# Work Order ID 92353

Item Name: Replacement Skidtube

| D2580-041 | (DEO) Rev.E |

| DRAWING NO.<br>D2580 | TITLE<br>205 SKIDTUBE ASSEMBLY | REV. E           | DART AEROSPACE LTD<br>ENGINEERING ORDER |  | D.E.O. NO.<br>D2580-E-1 | SHEET NO.<br>SHEET 1 OF 1 | SCALE<br>NTS |

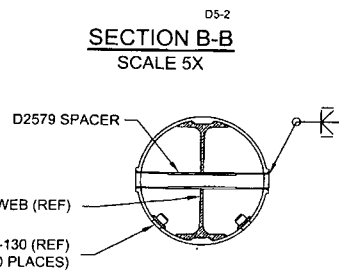
- IT IS ACCEPTABLE TO GRIND A RELIEF IN THE D2855 AFT CAP TO PREVENT INTERFERENCE WITH THE SPACER AT THIS LOCATION

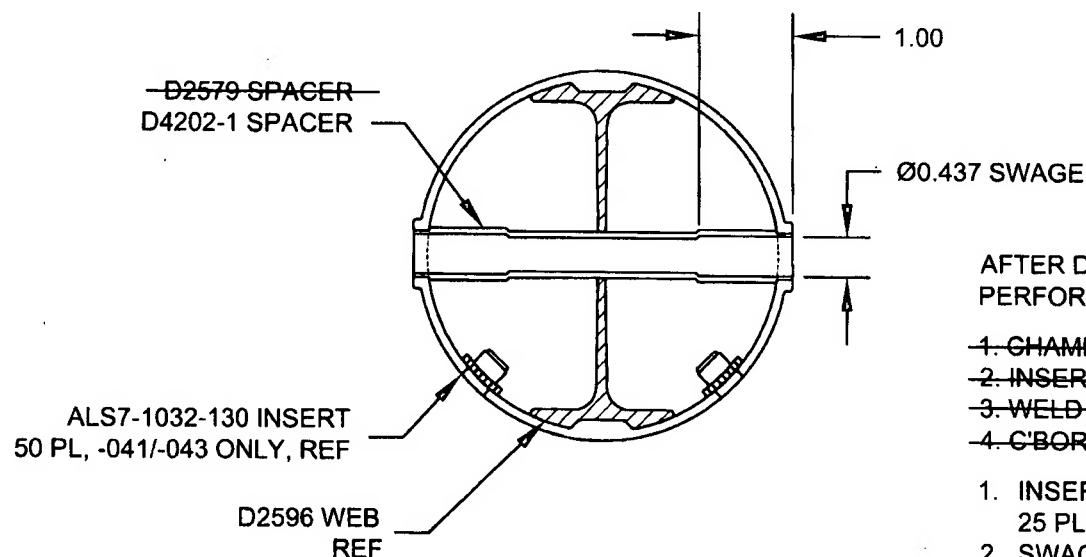
CHANGE ALL C'BORED WELDED CROSSBOLT SPACERS TO SWAGED SPACERS

| QTY  | QTY  | QTY  | PART NUMBER | DESCRIPTION       |
|------|------|------|-------------|-------------------|
| 20   | 24   | 25   | D2579       | CROSS BOLT SPACER |

|    | 4  |    | * D2579 | CROSS BOLT SPACER |
| 20 | 20 | 25 | D4202-1 | SPACER            |

WELD 4X D2579 SPACERS PER DWG  
IN LOCATIONS MARKED "NO C'BORE".  
REF SHEET 4 OF DWG.
